Town of Surfside

Dune Restoration Project

Addendum No. 3

Date Issued: February 11, 2026

SPECIFIC PURPOSE SURVEY

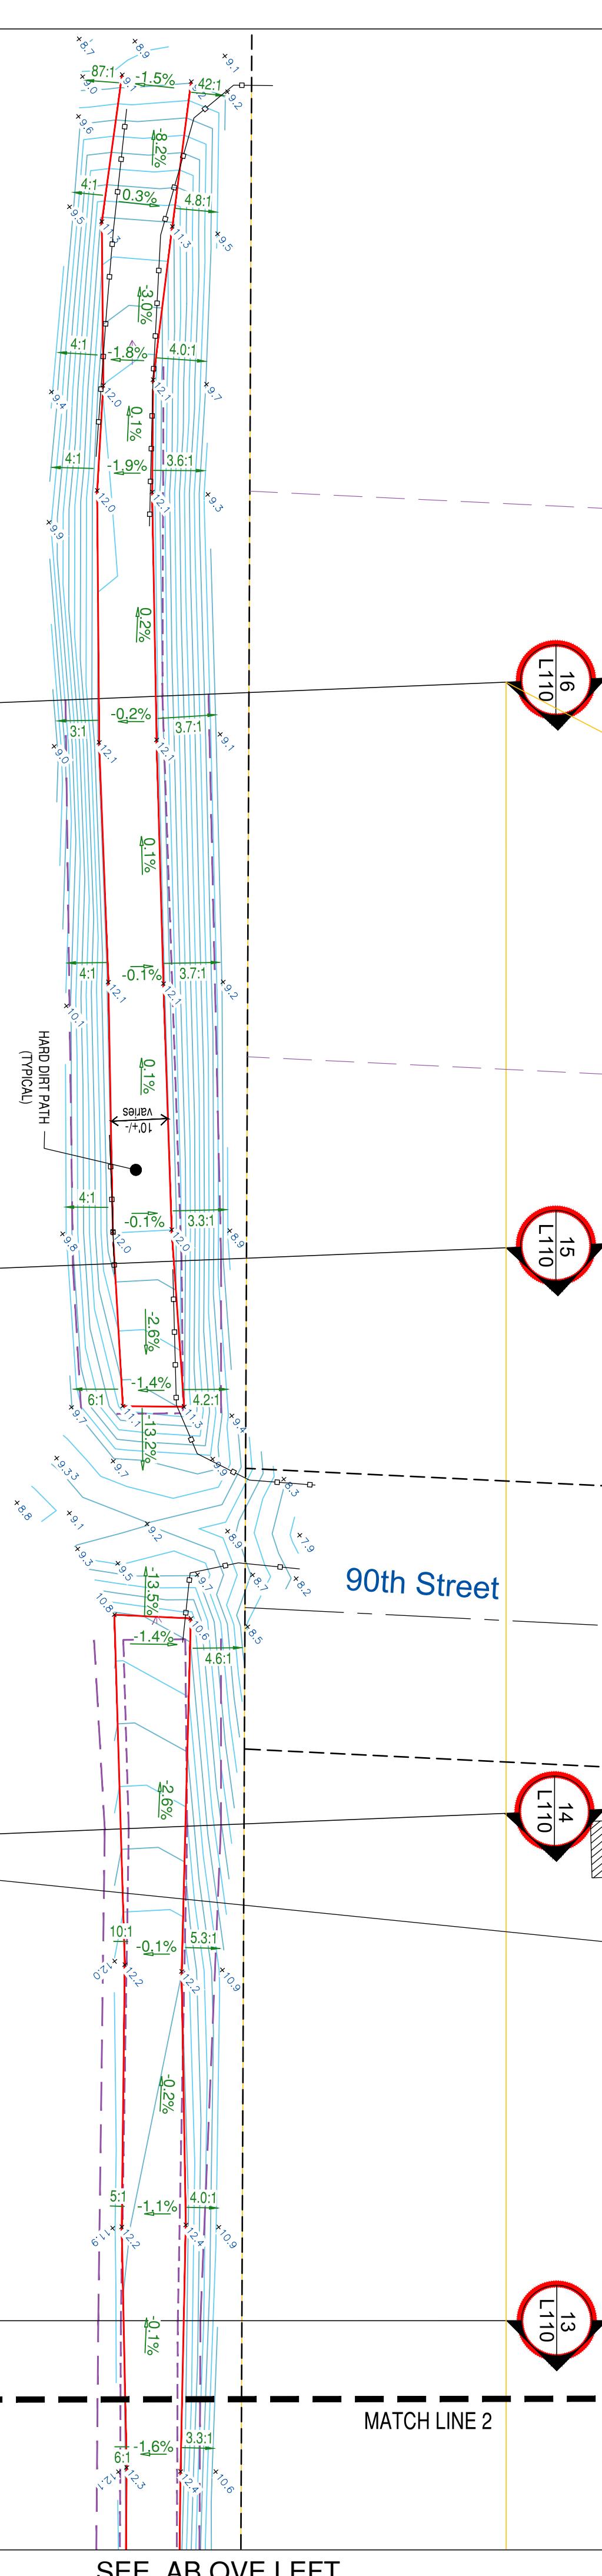
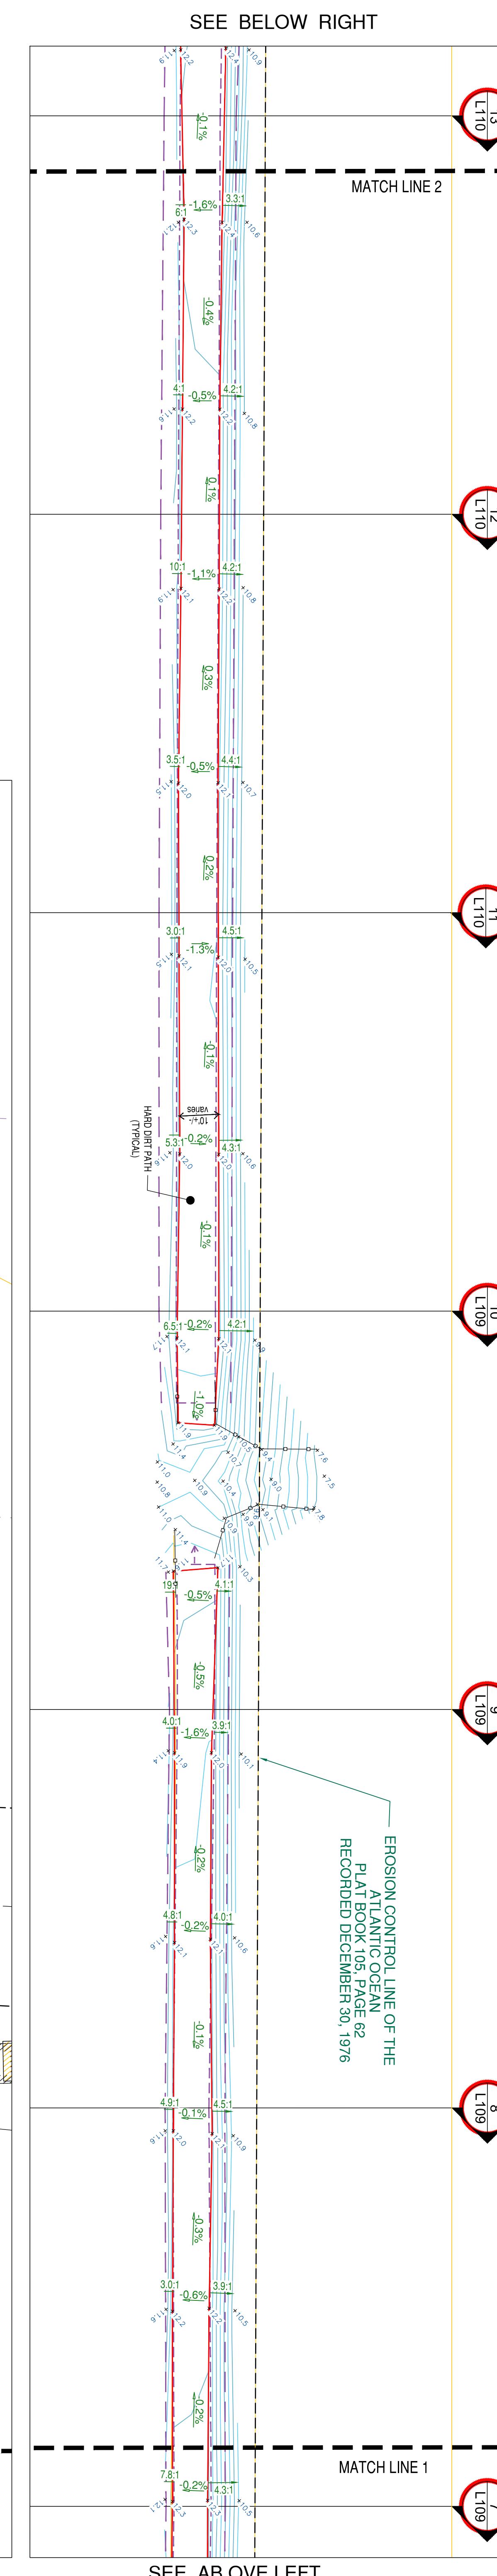
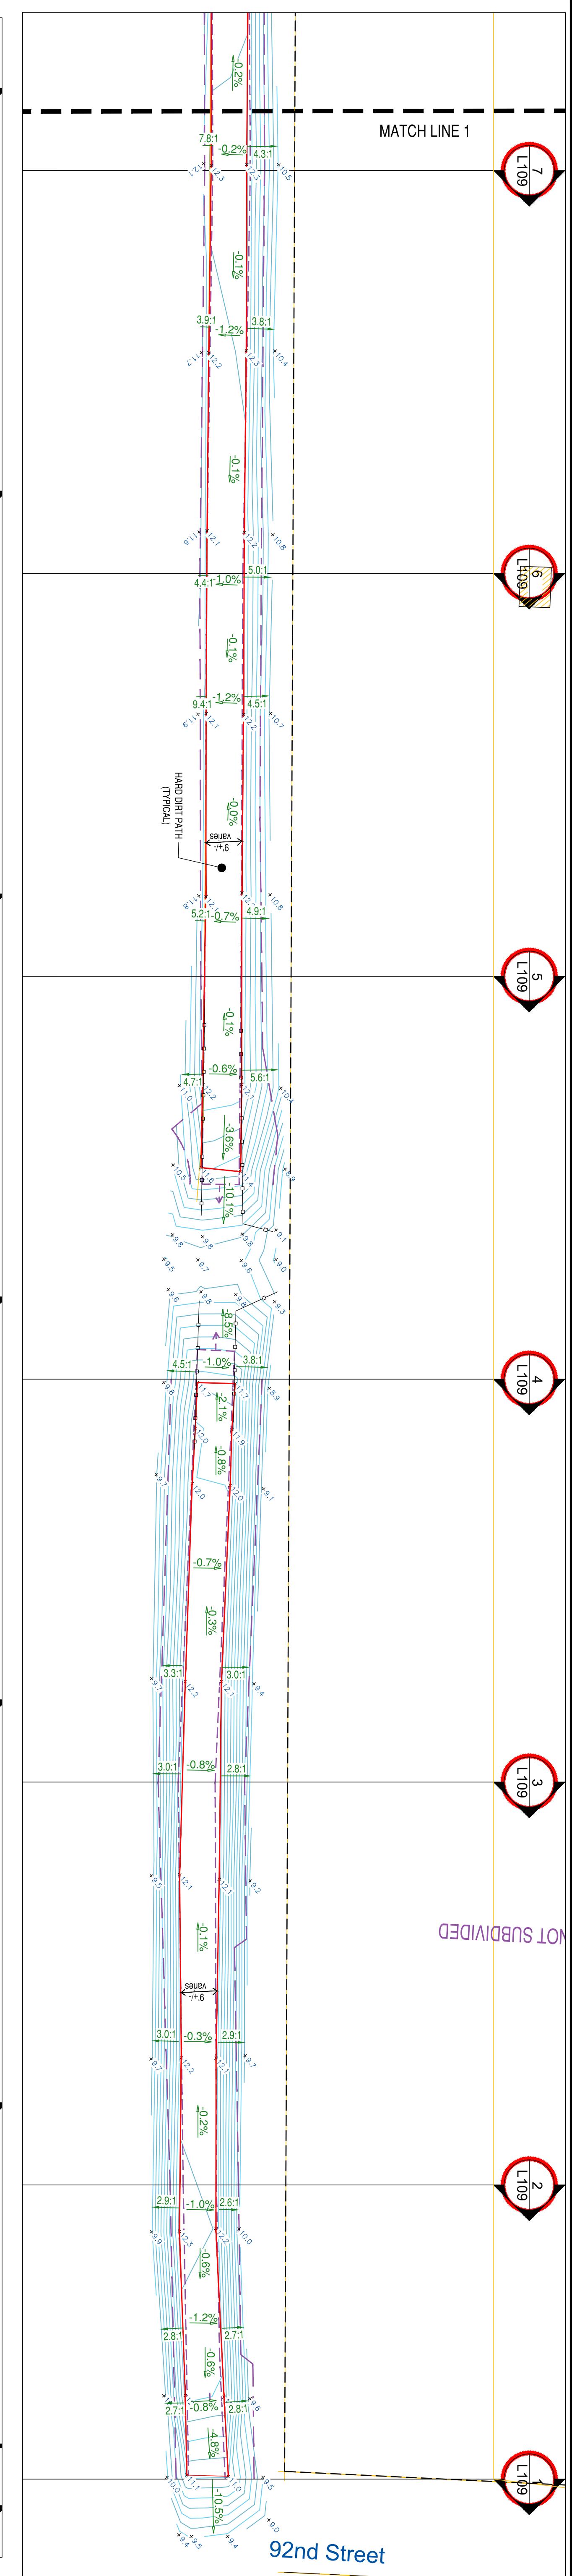
2. **Question:** Can you provide any available as-built information for the walking path under FDEP Permit No. DA000853?

Response: Attached is the as-built information currently available to the Town.
